Village of Arlington Heights
Conceptual Plan Review Committee
Community Room, 3rd Floor
Arlington Heights Village Hall, 33 S. Arlington Heights Rd.
July 28, 2021
6:00 PM

Conceptual Plan Review Committee
7/28/2021

REPORT OF THE PROCEEDINGS OF
THE CONCEPTUAL PLAN REVIEW COMMITTEE

Project Title: Ridgeline Distribution Center & Rohrman Auto Mall PUD
Address: 1100,1400 W. Dundee Rd. and 1510-1530 W. Dundee Rd
Petitioner: Ben Harris
Address: 2015 Spring Road – Suite 235
Oak Brook, IL 60523

Subdivision Site Plan

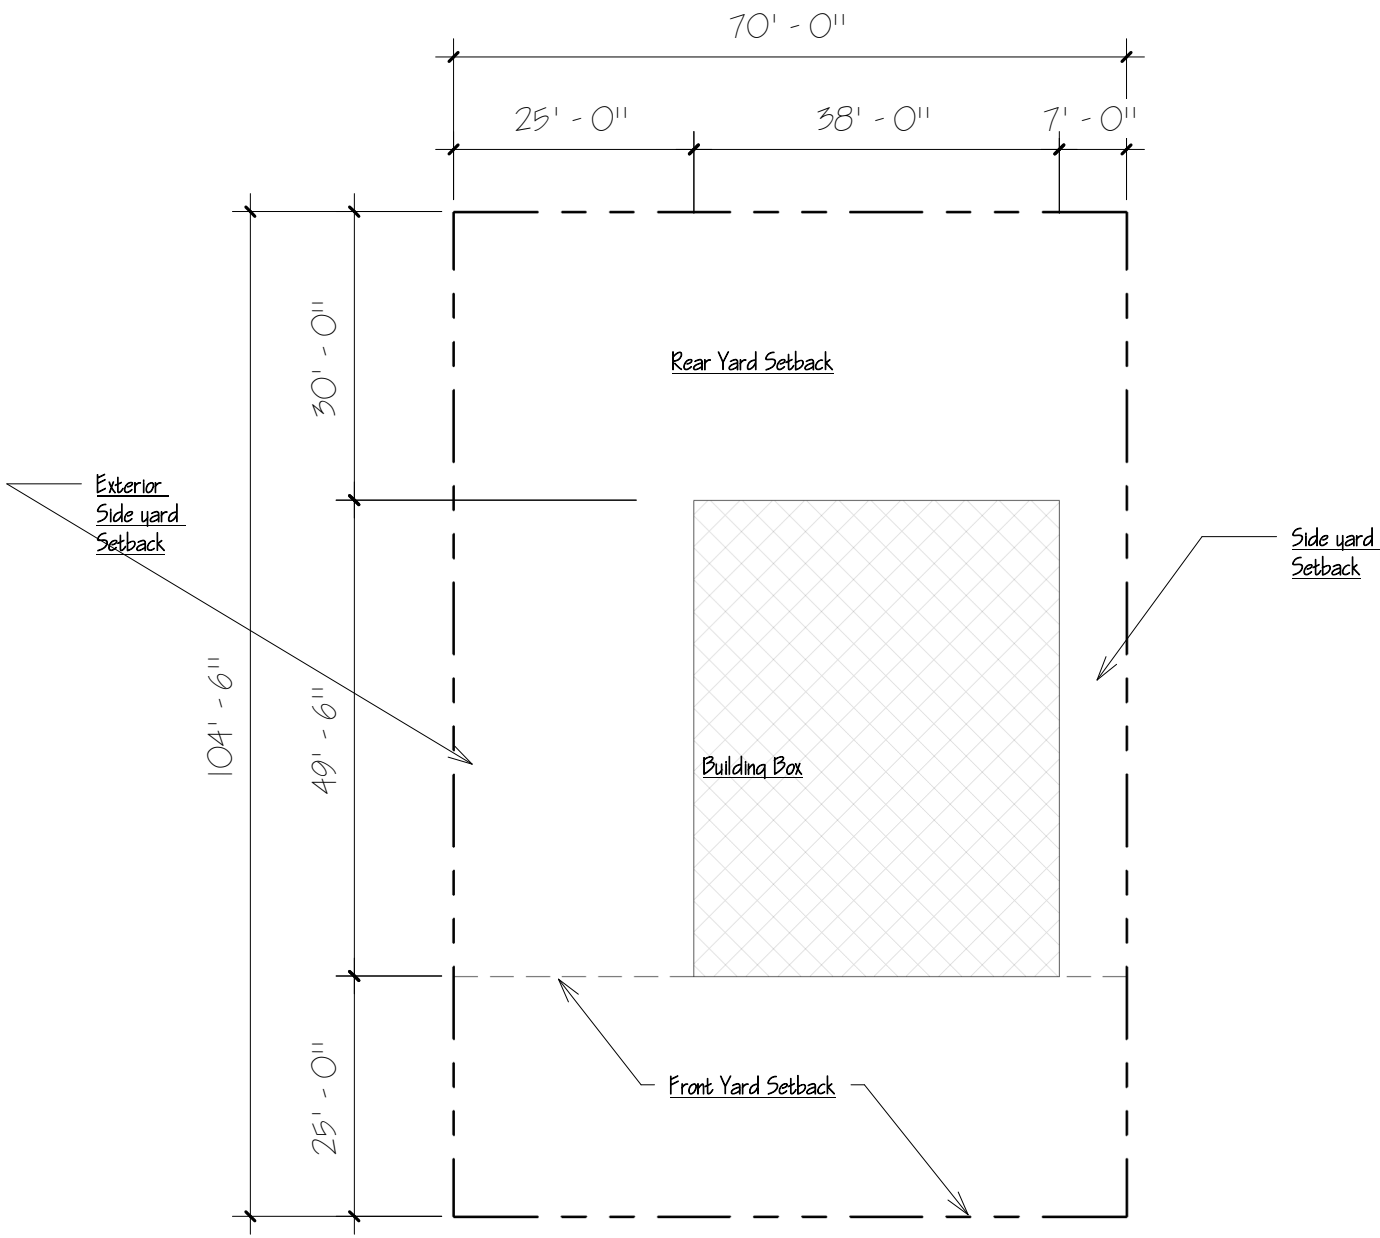
Based on a preliminary analysis of the proposed lots, all required setbacks are compliant on each lot. However, the petitioner should note that the exterior side yard setbacks for the corner lots will be based on the average setbacks of all existing homes on that frontage. The petitioner will need to provide an exhibit showing all existing setbacks on each frontage to allow staff to determine the required exterior side yard setbacks for Lot 1, Lot 8, and Lot 9.
